10 August 2017

Project No. 1661858-L-007-RevA

RE: BINGO INDUSTRIES – MINTO RESOURCE RECOVERY FACILITY, 13 PEMBURY ROAD
1.0 INTRODUCTION

Typical 4 axle truck and dog combination and double-B photos

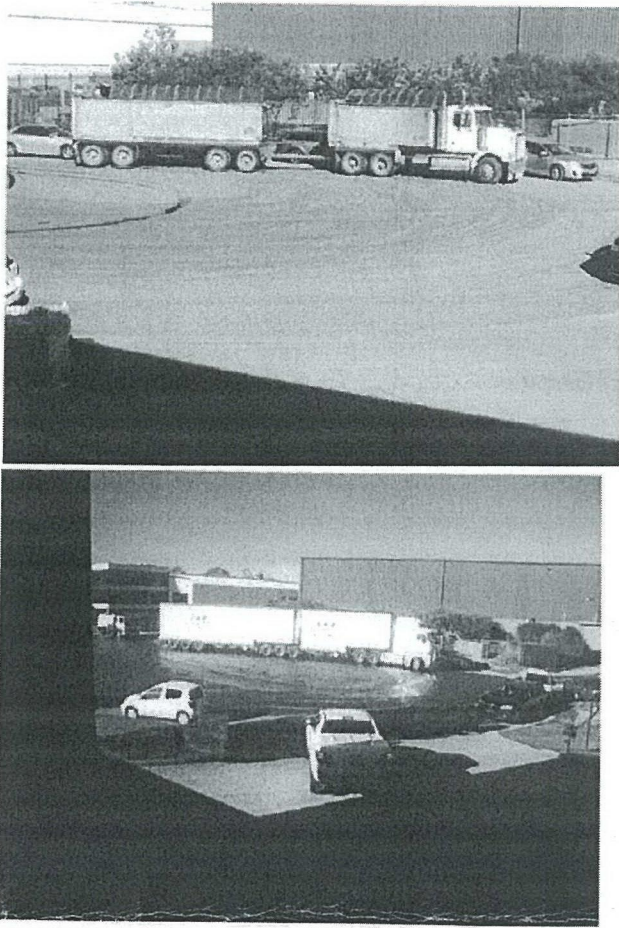
A Traffic Impact Assessment report was conducted by Transport Planning Partnerships for the proposed expansion of the waste transfer facility. Figure 2 of this report shows Pembury road (looking east) does not reflect the reality that is occurring on a daily basis within the Minto Industrial Estate where trucks, (double Bs) are parked along every available parking space and at some locations double parked as shown in the photos below.
